Addendum No. 4

Solicitation Number: *FY23-ITBCON-35*

Title: *Franklin Water Treatment Plant Clearwell Improvements*

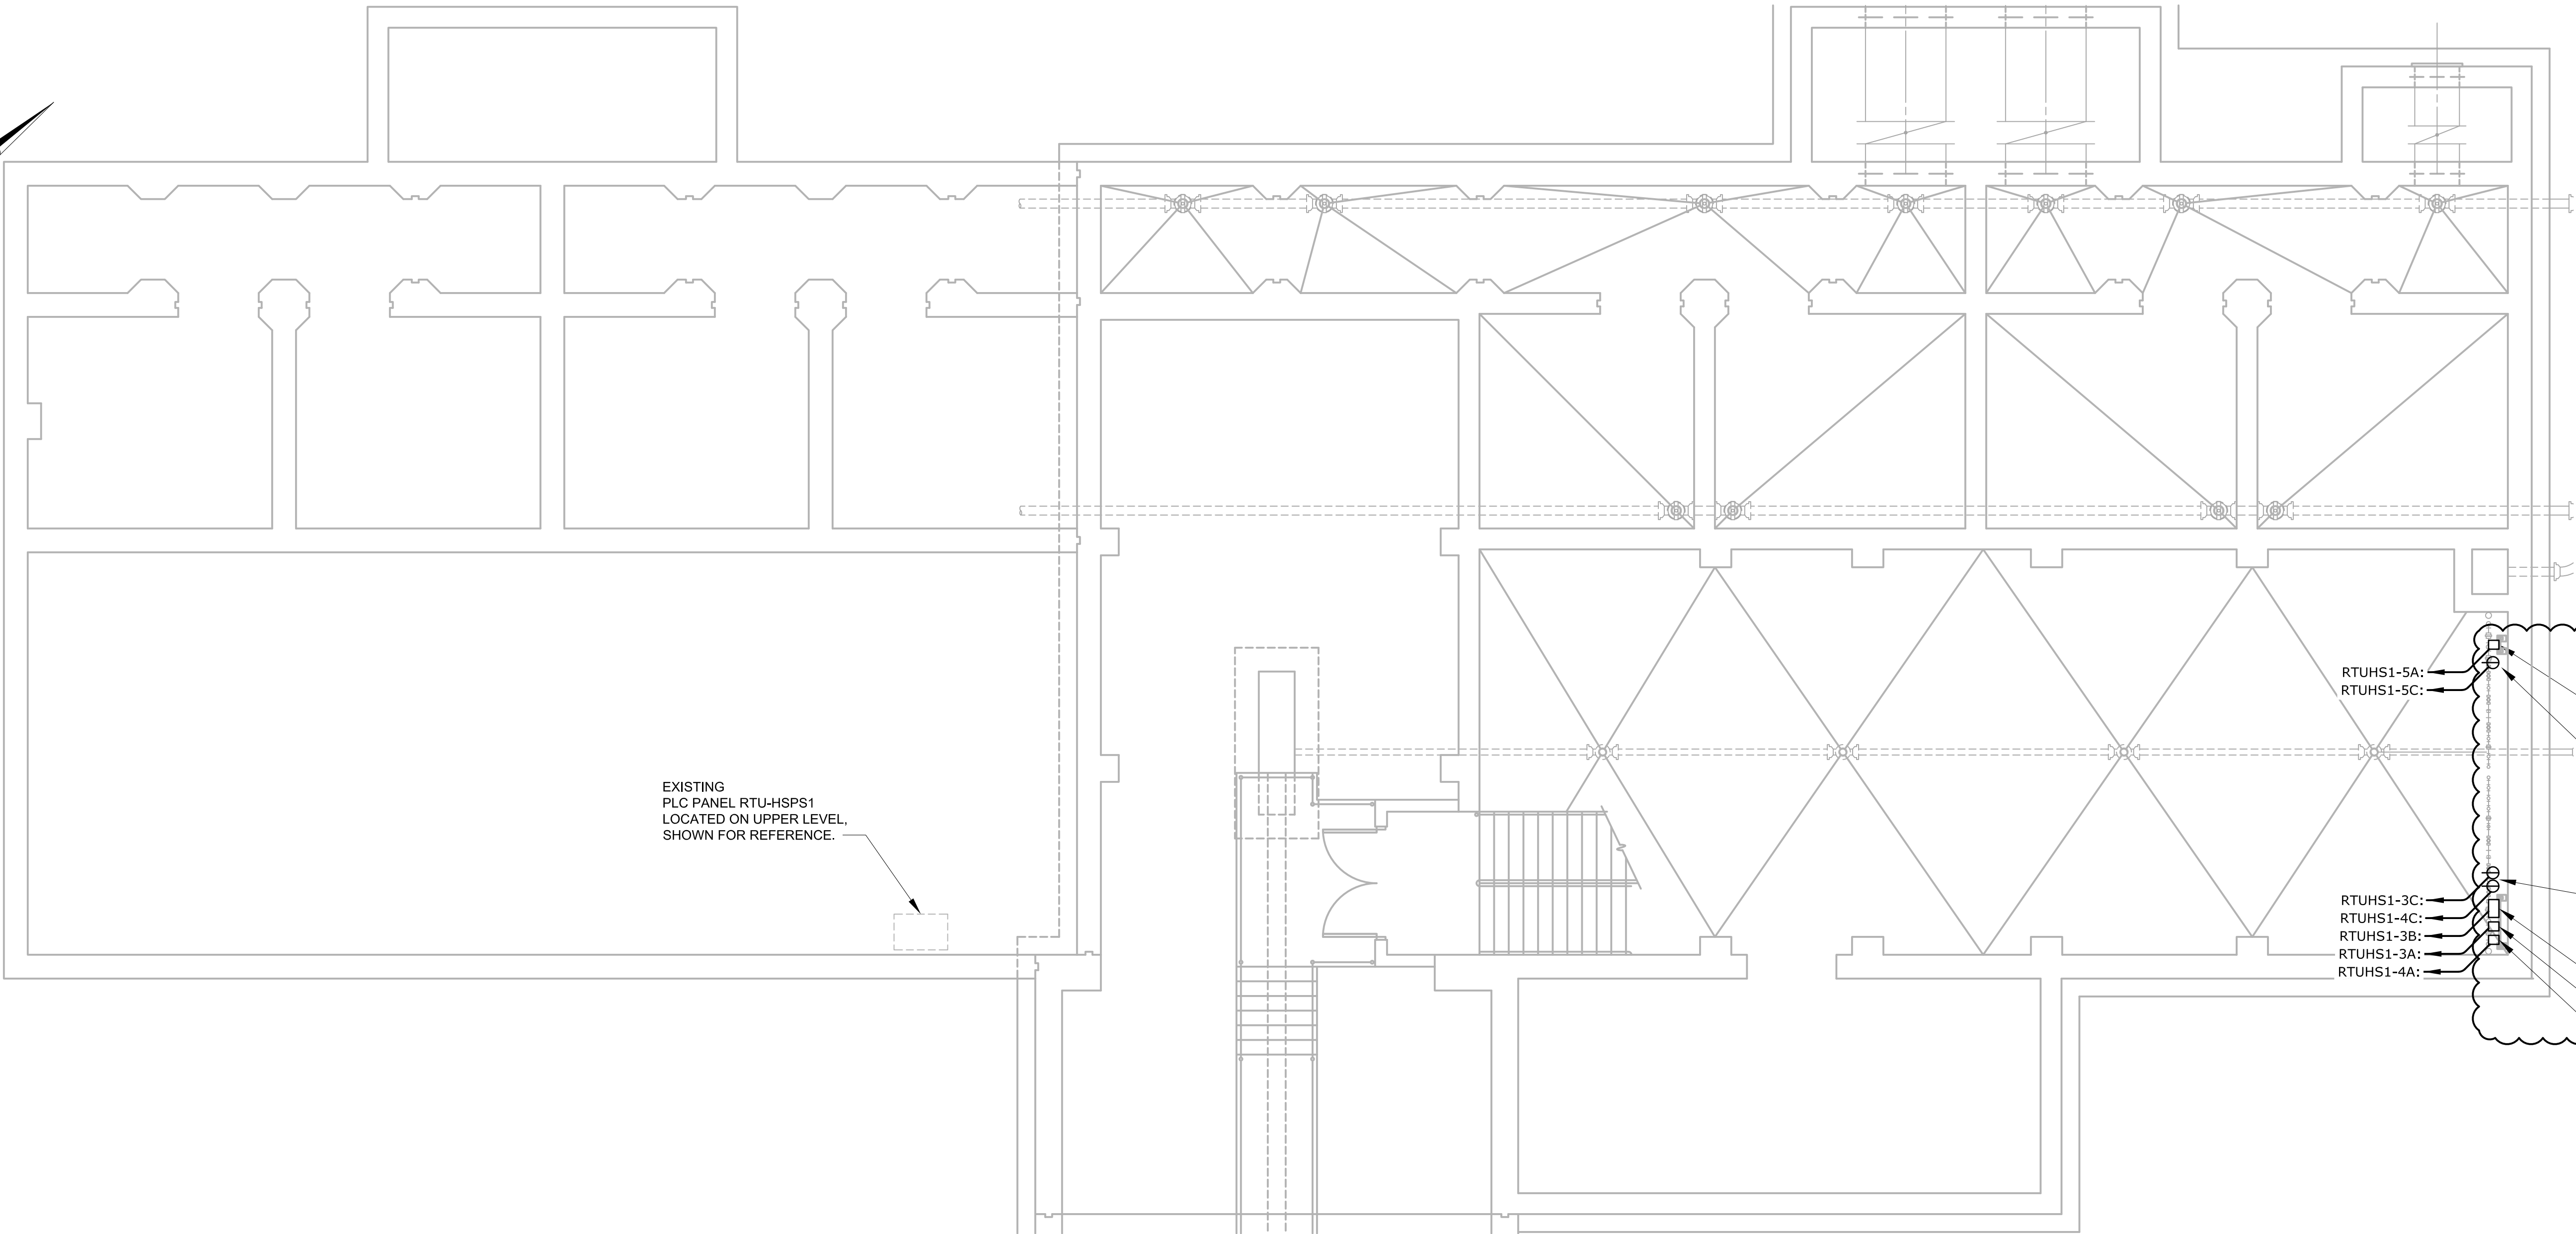
6	Contract Drawing E10, Proposed Site Electrical Overall Site Plan	Revision No. 3	Replace Contract Drawing E10 in its entirety with the attached revised Contract Drawing E10. It has been revised to show location of telephone junction boxes, existing handhole, existing manhole, the polymer building, and circuits JBT1-1 and MHDOT1-1. It has also been revised to show corrected LP2 circuit names, and Note 14 has been modified.

DATE:	APRIL 2023
HAZEN NO.:	30563-027
CONTRACT NO.:	1
DRAWING NUMBER:	E400

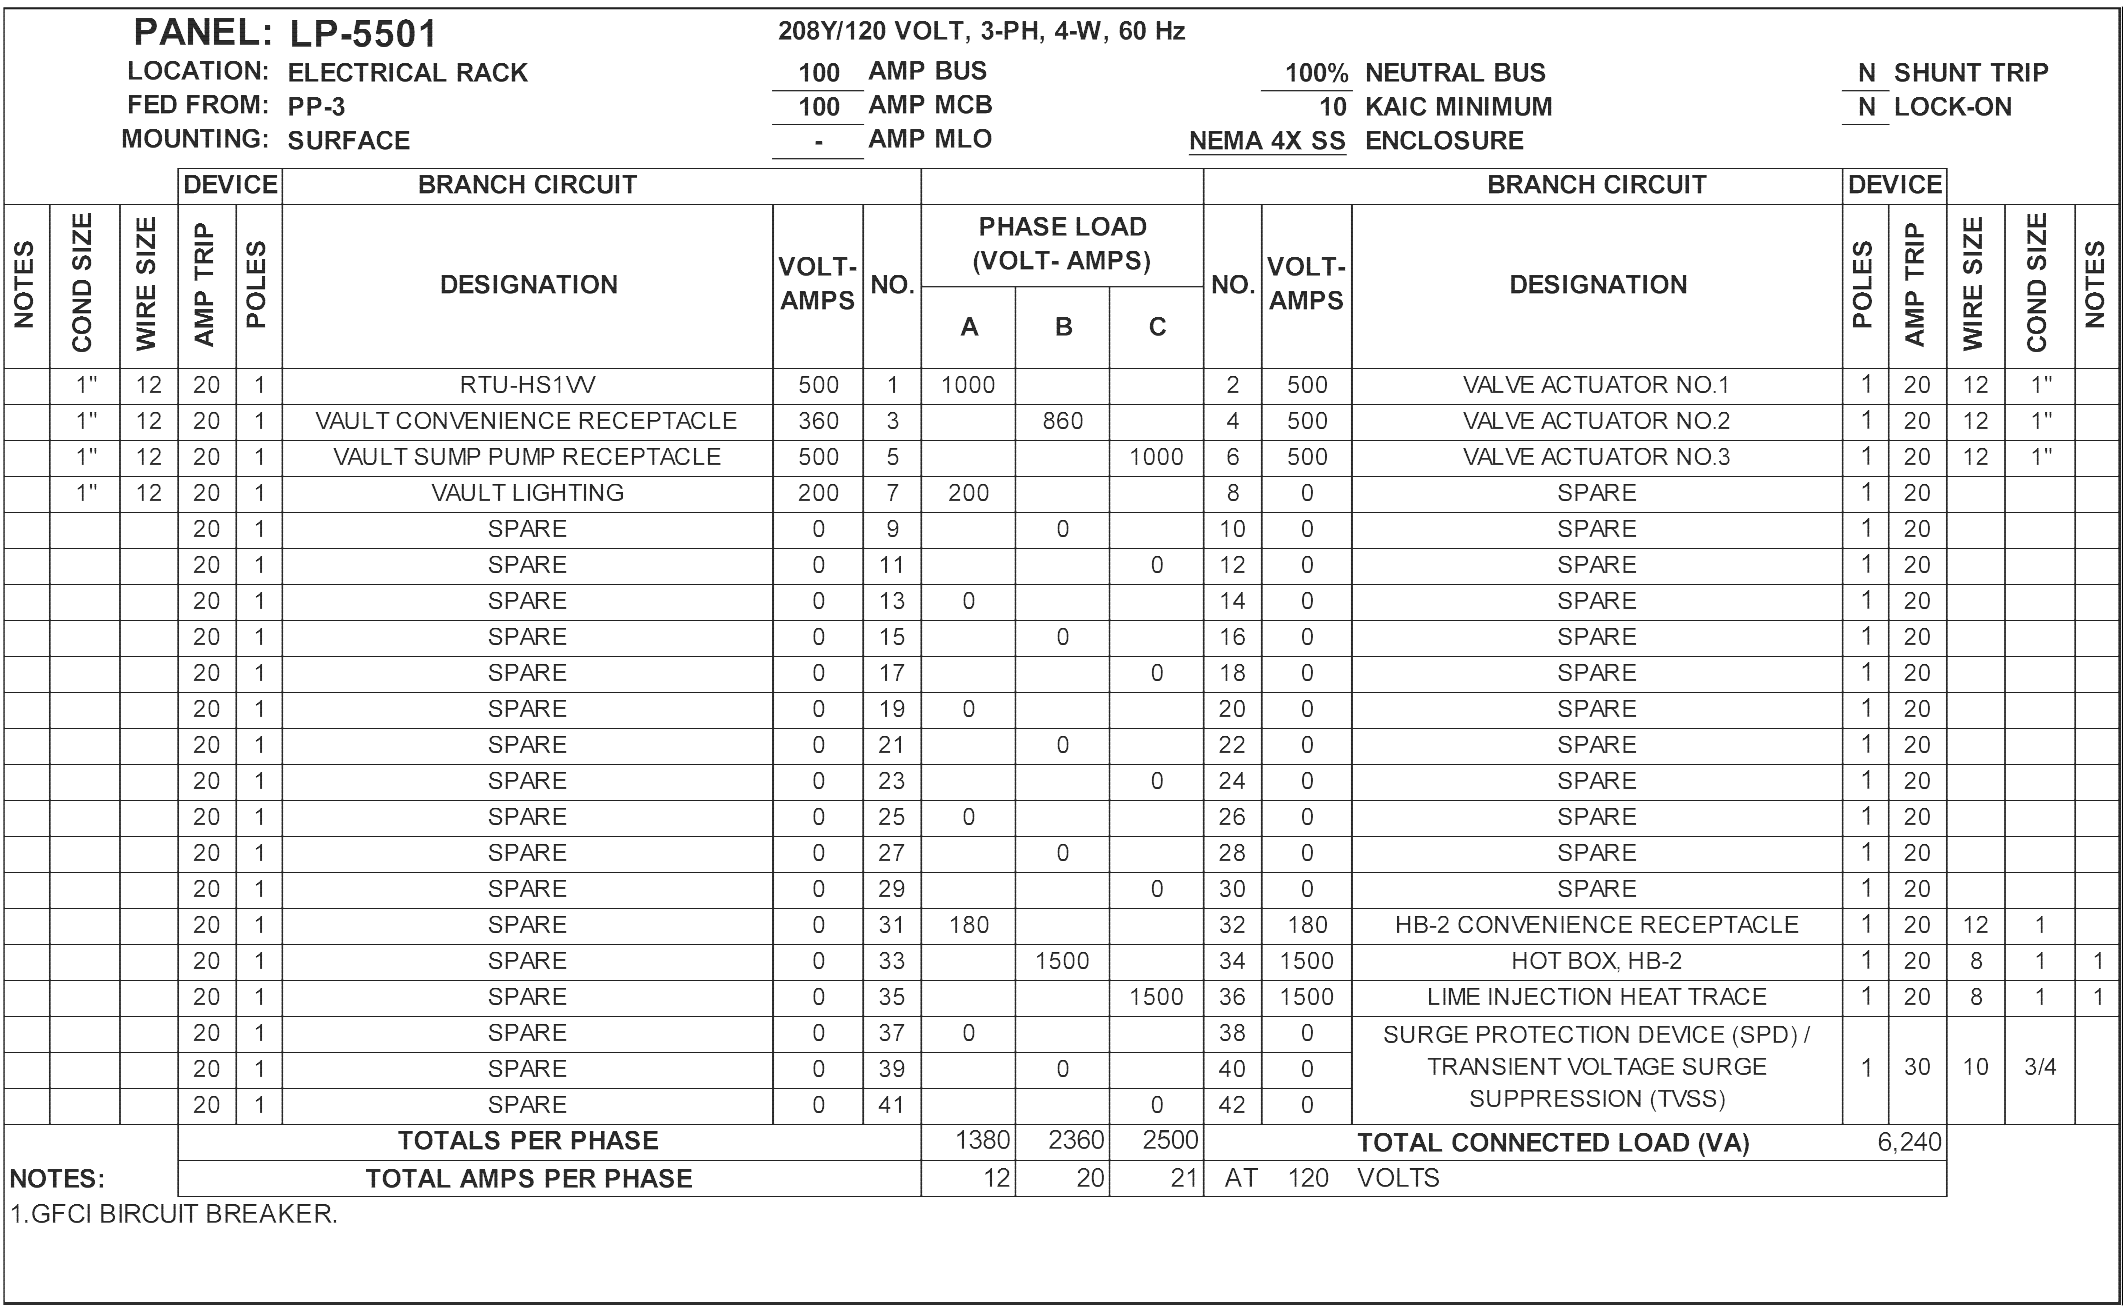
7	Contract Drawing E400, High Service Pump Station No.1 Electrical Power Plan	Revision No. 3	Replace Contract Drawing E400 in its entirety with the attached revised Contract Drawing E400. It has been revised to show the instrument transmitters being installed on PVC sheet with receptacle also installed on the PVC sheet.
8	Contract Drawing E552, High Service Pump Station No.1 Valve Vault Electrical One Line Diagrams	Revision No. 3	Replace Contract Drawing E552 in its entirety with the attached revised Contract Drawing E552. It has been revised to show the valve actuators being furnished by the Owner, installed by the Contractor as well as increasing the ampere rating of the disconnect switch.
9	Contract Drawing E700, Dewatering Building Electrical One Line Diagrams	Revision No. 3	Replace Contract Drawing E700 in its entirety with the attached revised Contract Drawing E700. It has been revised to show additional conduit runs, and the conduit sizes have been enlarged.
